PROVENCE ESTATES REZONING PLAN

PETITION NO: Z-56

Z-56 2017-GIS

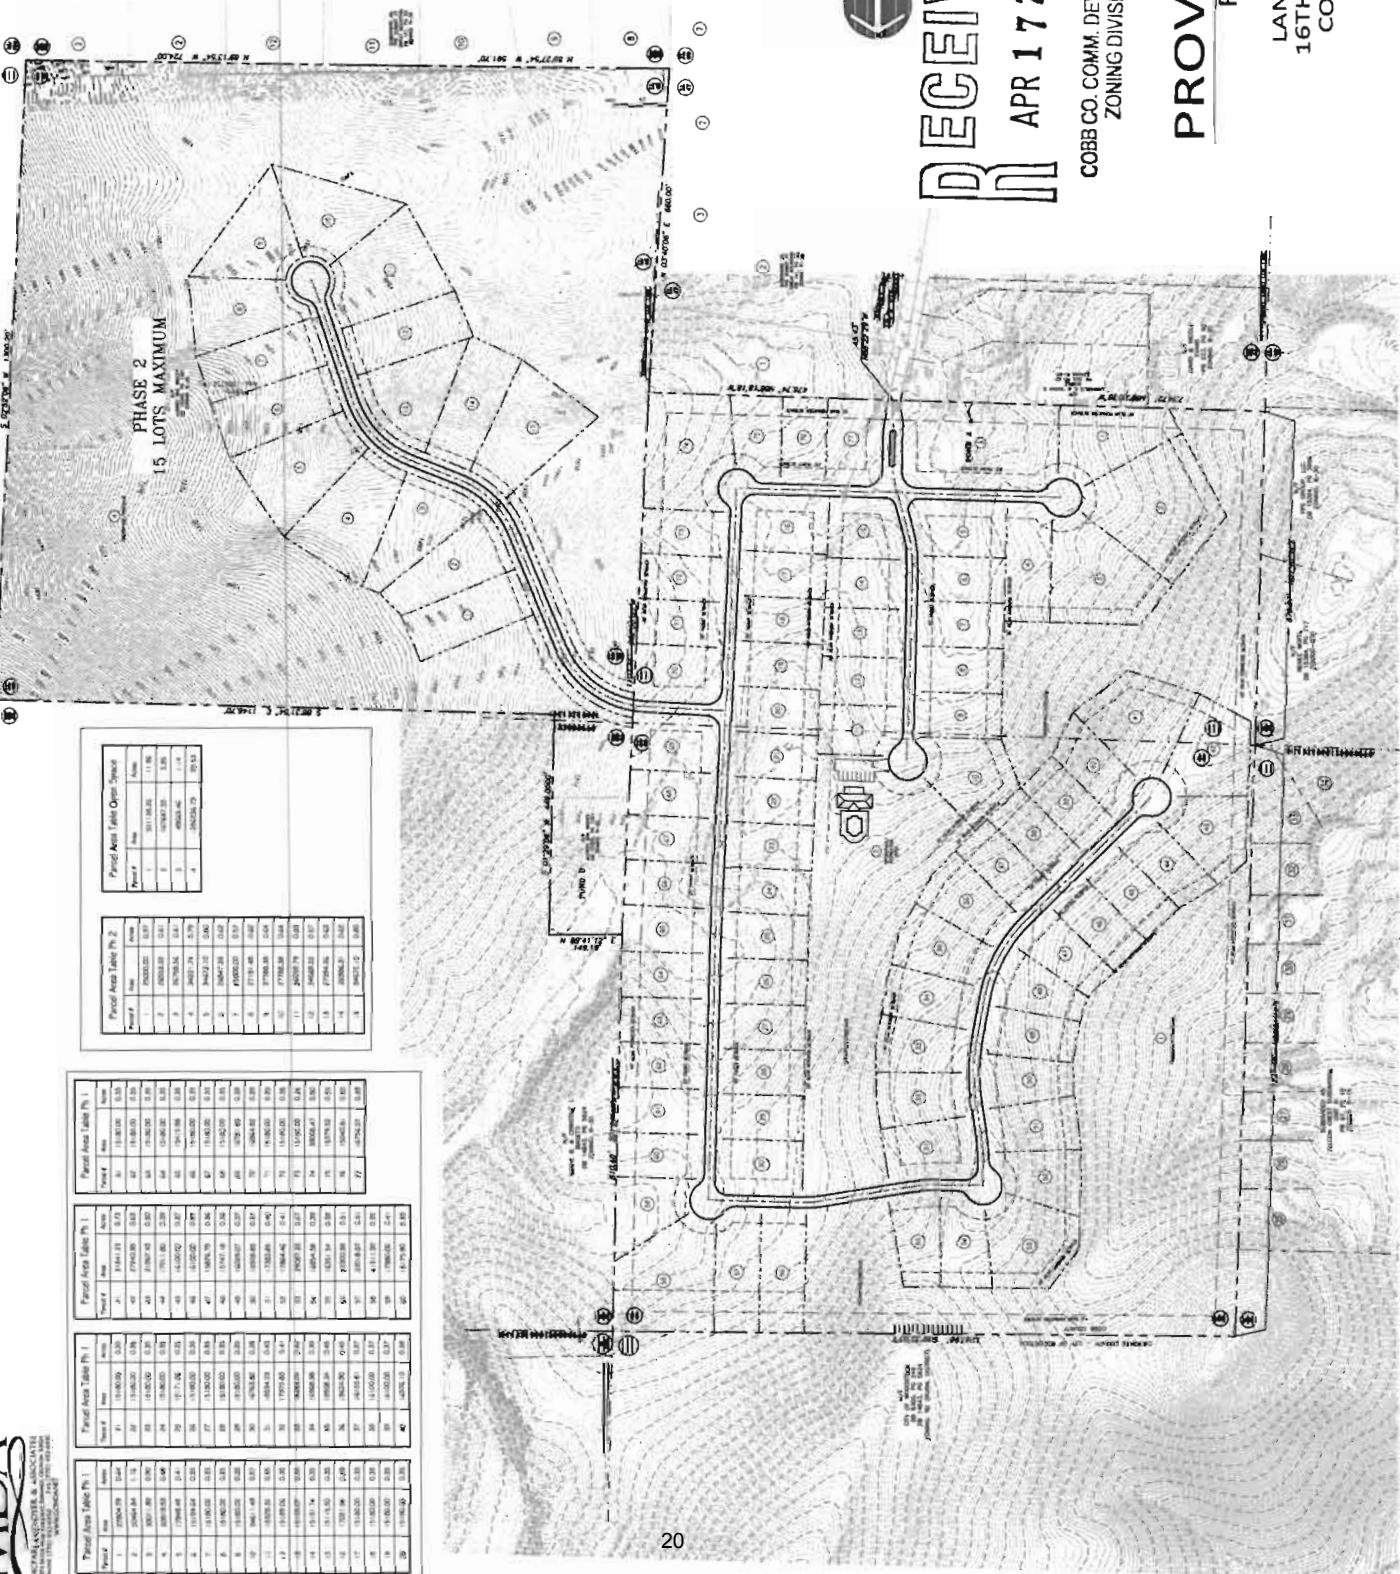
- 1.) Impervious surfaces of amenity areas should be subtracted from the total area to determine Net Buildable Area. Please provide acreage of the impervious surface of amenity area. Also, please note on plan that no floodplains, wetlands and/or cemeteries are evident on site, if that is indeed the case.

- 2.) Proposed open space on site plan (46.48 acres or 48.3%) does not match the percentage open space that is referenced in Item #1 (45%) in the April 17, 2017 stipulation letter.

- 3.) Slopes greater than 25 percent must be included in the required open space, but shall allow for perpendicular (except when non-perpendicular is necessary to satisfy drainage/storm water requirements) utility and access crossings, when necessary. Based on GIS generated slope analysis, there are several lots that encroach into slopes greater than 25%.

- 4.) The buffer area on the southern and eastern portions of the subject property show 40 foot. Item #2 of the April 17, 2017 Stipulation letter says 50 foot. Please show 50' undisturbed buffer along the southern and eastern portions of the subject property, as well as to the rear of lots 42 and 43 on the western side of subject property.

- 5.) Allow pedestrian access to the open space pocket located in the southwest portion of the tract (likely to the rear of lot 10).
- 6.) Either on the plan or in stipulation letter include language referencing fencing that is compatible with the architecture/landscape/design of development shall be established along lot lines that are contiguous to open space.
- 7.) A Conservation Easement must be recorded in the mandatory subdivision covenants and with Cobb Superior Court, thereby protecting the “Open Space” from development in perpetuity as owned by the mandatory Home Owners Association. Conservation Easement application must be submitted to the Planning Division before final plat approval.
